**MANDATORY BULLETIN No. EV 97 – 015 a
SPORTSTAR – 014 a**

1. **CONCERNING TO:** All **EV-97 Eurostar** and **SportStar** airplanes manufactured until June, 2010.
2. **REASON:** A loosening of brake hoses in the area of hand control system was found on one of the airplanes in operation. Loosening was caused due to a plastic square anchor, which become detached from the airframe. The hoses are fixed to these plastic anchors by means of zip ties. See the picture in Appendix 1.
In certain circumstances the loose hoses may restrict movement of the hand control system.

Appendix 2 Current Design Hose Attachment

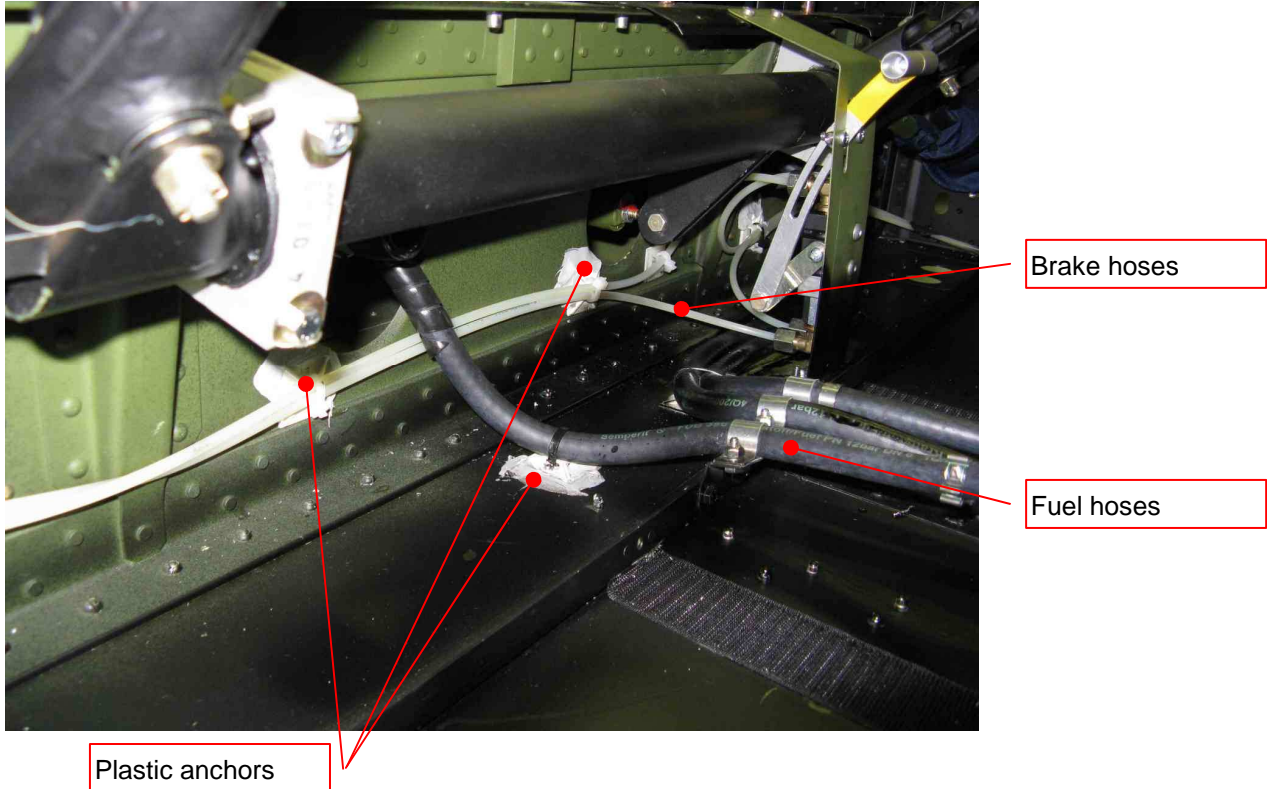
The picture below shows one of the methods used on currently produced airplanes to attach the hoses and wiring. There are square plastic anchors attached to the airframe, either by glue or by the adhesive patch on the rear of the anchors. The zip ties are inserted through the anchors and hoses (fuel, brake) or wires are fixed in place by these zip ties. Some of the anchors may become detached under certain circumstances and thus hoses may become loose. Loose hose may subsequently restrict hand control system movement.

Appendix 3 Procedure to Improve Hoses Attachment

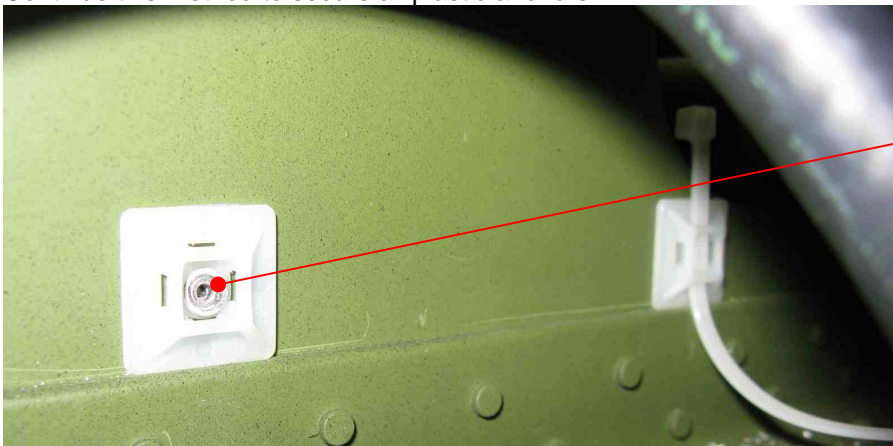
1. Remove upholstery from both seats
2. Remove left and right hand control covers in front of the seats.
3. Visually and by hand check attachment of the hoses in the area of hand control system. The hoses may not be loose and/or come into contact with either part of hand control system. All plastic anchors must be firmly fixed to the construction.

4. Perform improvement of the hose attachments as follows:
 1. Use cutting pliers to cut a zip tie, remove cut zip tie, move the hose slightly away of the plastic anchor, drill hole through the anchor center by means of a hand drill and 3.4 mm diam.drill bit (be careful to not drill through any installation which might be on opposite side of drilled part; use of a small mirror and light source is recommended), pull new zip tie through the plastic anchor, place hose back into position and tighten the zip tie to fix the hose. Cut loose end of the zip tie. Be careful so that the cut sharp end of the zip tie does not damage any of surrounding hoses or wires. Continue this method to secure all plastic anchors.

2. Alternatively, it is acceptable to leave the hose attachment as they are and install additional suitable hose clamps of appropriate size. They can be attached mechanically (either by rivets or bolts and nuts) to the airframe in suitable places close to the original plastic anchors. Attach the hoses to these additional clamps.
5. Record performance of the bulletin into the Airplane Log Book.
